Access Compliance Report

Public Rights-of-Way

(Curb Ramps)

Intersection ID: 52535	Main Street: TAMARRON_DR	Cross Street: CLAVEMORR_CASTLE_CT	Location: SW
ADA ID: 184CC5863AC7	Ramp Type: PerpDiag	Initial Pass/Fail: Fail	Overall Compliance: No
Severity Score: 10			
Codes/Mitigation Info/Possible Solution		Field Measurements/Component Compliance

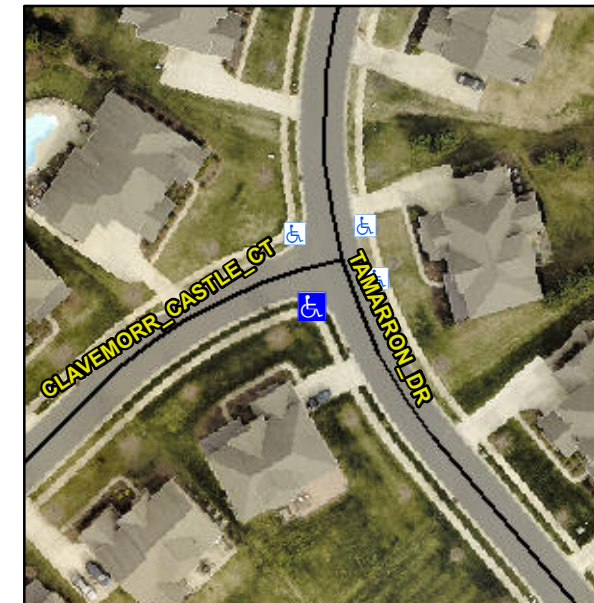
Not Found, R304.5.1, R304.5.3

Compliance	Description	Data	Compliance	Description	Data
N/A	Ramp Length (in)	48.0	Yes	Ramp Slope (%)	5.0
No	Ramp Width (in)	47.0	No	Ramp XSlope (%)	3.2
N/A	Flare Type LT	N/A	N/A	Flare Type RT	N/A
N/A	Flare Slope LT (%)	N/A	N/A	Flare Slope RT (%)	N/A
N/A	Flare Traversable LT?	N/A	N/A	Flare Traversable RT?	N/A
N/A	Landing Length (in)	N/A	N/A	DWS Provided?	N/A
N/A	Landing Width (in)	N/A	N/A	DWS Contrast?	N/A
N/A	Landing Slope (%)	N/A	N/A	DWS Length (in)	N/A
N/A	Landing X Slope (%)	N/A	N/A	DWS Full Width?	N/A
N/A	Landing Curb? (Y/N)	N/A	N/A	DWS Offset (in)	N/A
N/A	Shared Landing?	N/A			
N/A	Gutter Ponding?	N/A	N/A	Gutter Slope (%)	N/A
N/A	Gutter Lip Ht (in)	N/A	N/A	Gutter X Slope (%)	N/A
N/A	Painted X Walk1?	No	N/A	Painted X Walk2?	No
	X Walk 1 Direction	To E		X Walk 2 Direction	To N
N/A	X Walk 1 Width (in)	N/A	N/A	X Walk 2 Width (in)	N/A
	X Walk 1 Slope (%)	4.0		X Walk 2 Slope (%)	3.8
	X Walk 1 X Slope (%)	3.1		X Walk 2 X Slope (%)	0.4

Remove & Replace Curb Ramp With Two New Directional Ramps or Equivalent.
